**CITY OF SNELLVILLE
DEPARTMENT OF PLANNING & DEVELOPMENT
PLANNING COMMISSION**

CASE NUMBER: #CUP 18-02

**CONDITIONAL USE PERMIT
REQUEST:** Re-open Existing Fuel Station with
Convenience Store and Request for Variances

DEVELOPMENT/PROJECT: Fuel Station with Convenience Store

The proposed site plan, with the area being taken by GDOT in black hatching (labeled Tract 2).

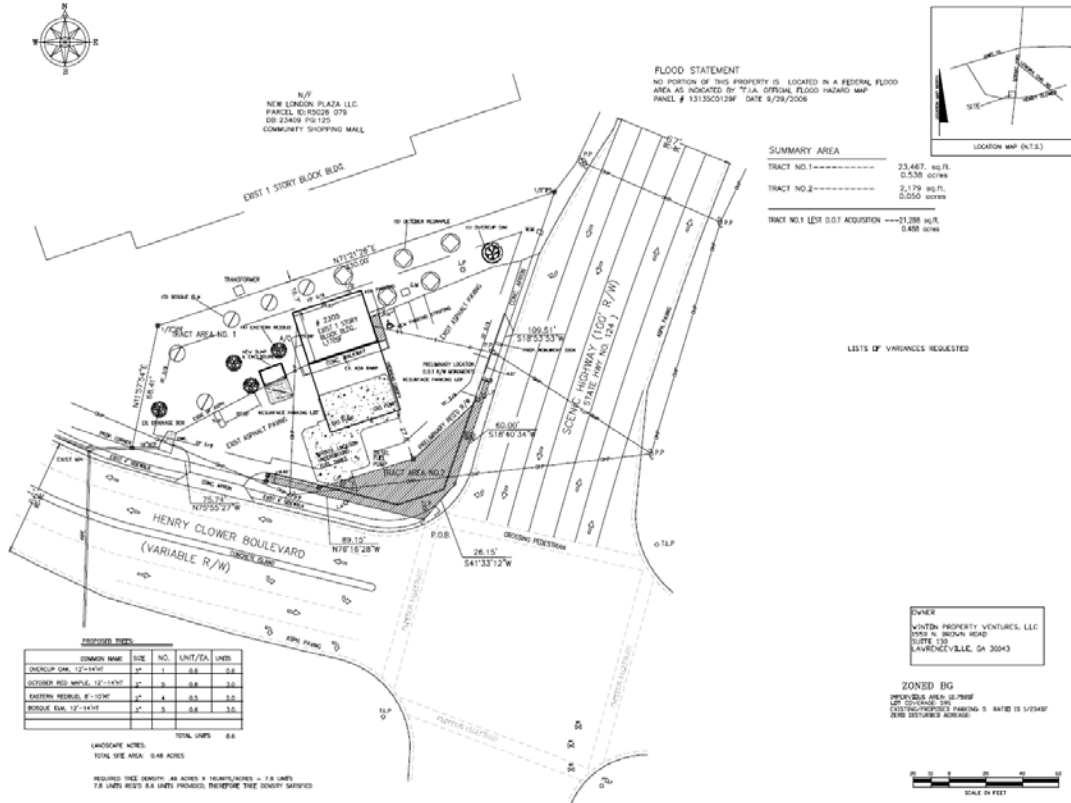
The R/W acquisition complicates renovation of the property. It takes away usable space for front landscape strips, making compliance with landscape and buffer requirements difficult. However, there is plenty of area for greenery on the rear of the property, in what is now a bare

grassy hillside. The layout of the parking lot also makes landscape islands impractical, but the size of the lot will anyway be reduced by the R/W acquisition.

The fuel tanks are existing and will be located within 30' of the new property line after the GDOT acquisition, not through any action of the property owner. The request is reasonable.

The applicant is proposing shrubs in the front landscape strip, but is asking for relief from planting them until the R/W work being done by GDOT is completed. The request is reasonable, so long as the applicant agrees to plant within a timeframe prescribed by the City.

Though the Corridor Overlay requires 6' sidewalks on commercial properties, GDOT plans to install 5' sidewalks on the ROW they have acquired. Since this forms the majority of the road frontage of the property, the applicant should be required to fill in the rest with sidewalks that match the intended width. This request is not recommended for approval.

4. Sidewalks shall be provided along the entire frontage of the development along both Henry Clower Boulevard and Scenic Highway. These sidewalks shall be 5' in width, to match those being installed by the Georgia Department of Transportation.

5. The property owner is to meet the required Tree Density Units (TDUs) for the property within the rear of the property that is currently a grassy hill. As a requirement for the release of any Certificate of Occupancy from the City, the tree and landscape improvements within the grassy hill shall be completed.
